TECHNICAL ANALYSIS
OF THE SKYLINE
MINING AND RECLAMATION PLAN

Prepared for
United States Department of the Interior
Office of Surfacing Mining Reclamation and Enforcement

Draft Final Report - Task Order No. 8
Skyline Mine Plan
Contract No. J5191336
Environmental Analyses of Surface Mining and
Reclamation Plan for Federal Coal Leases

FIGURE 3
ECCLES CANYON

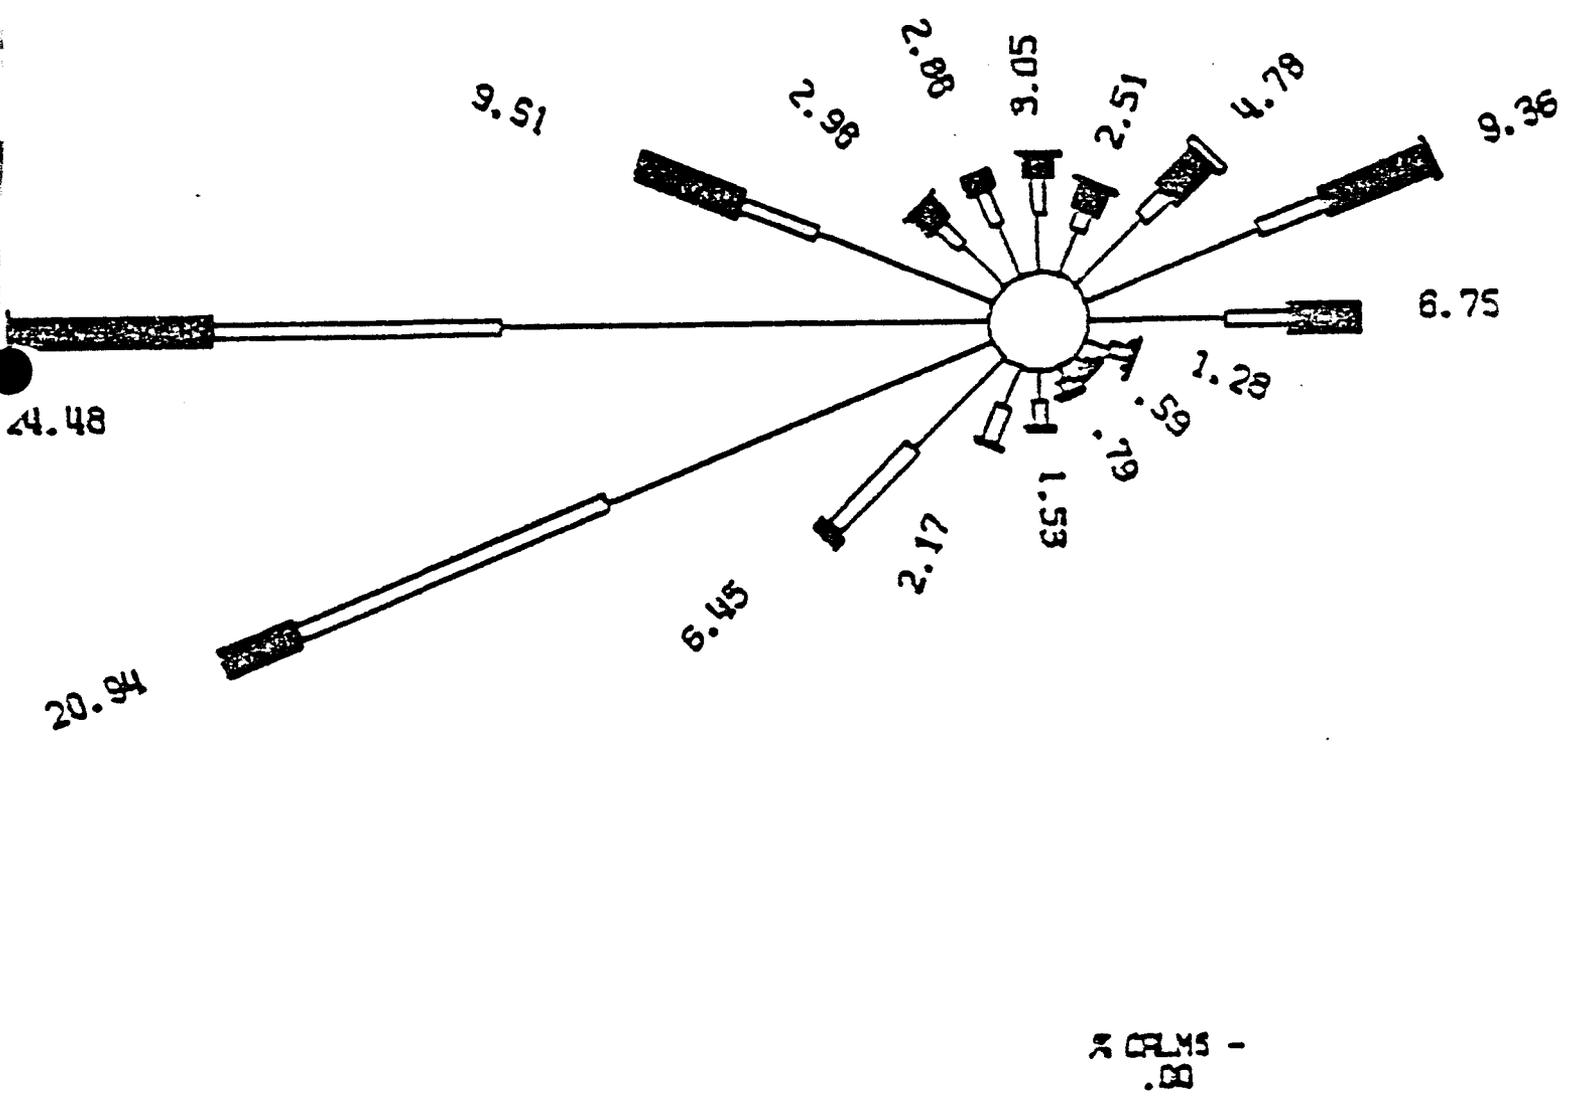
2. The fugitive dust control program as proposed by the Skyline Mine in Volume III, aside from a few minor deficiencies, is adequate. The map of the monitoring stations (Figure 4) and site vicinity map (Figure 5) show the complexity of the terrain surrounding the proposed mine site. The data from the particulate monitoring program should have listed daily readings for the Boardinghouse Peak station instead of monthly averages to determine if the 24-hour TSP standards are met. A comparison was not made nor data tabulated from the ten sampling days that were reported as coincidental to both the Boardinghouse Peak and Eccles Canyon sites. The coincidental sampling days would allow a comparison of the two sites to be made during various meteorological conditions. The Eccles Canyon particulate sampling site at the proposed portal location is within 60 feet of the dirt road following along the base of Eccles Canyon since the high-volume sampler and portable generator could not be separated further than 60 feet from the dirt road. Although the road is open in summer months and traffic is light, the proximity of the dirt road will most likely have a significant effect on measured TSP levels. The road will eventually be paved which will reduce measured concentrations.
